Access Compliance Report Public Rights-of-Way (Pedestrian Signals)

Main Street: **CHAPMAN_AVE** Cross Street: **BEACH_BLVD** Location: **SE**

ADA ID: **SGRK210928151722** Signal Type: **One Push Button-Non APS** Overall Compliance: **No** Severity Scores: **BTN 1: 35** **BTN 2: N/A** **No BTN: N/A**

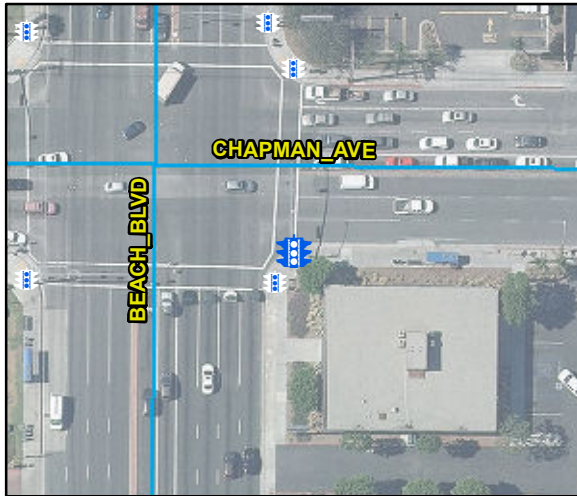
OC Std/PROW: **R404.2, R404.3, MUTCD 4e.08**

Possible Solutions: Replace Signal Push Button With APS Button. Remove and Replace Clear Space.
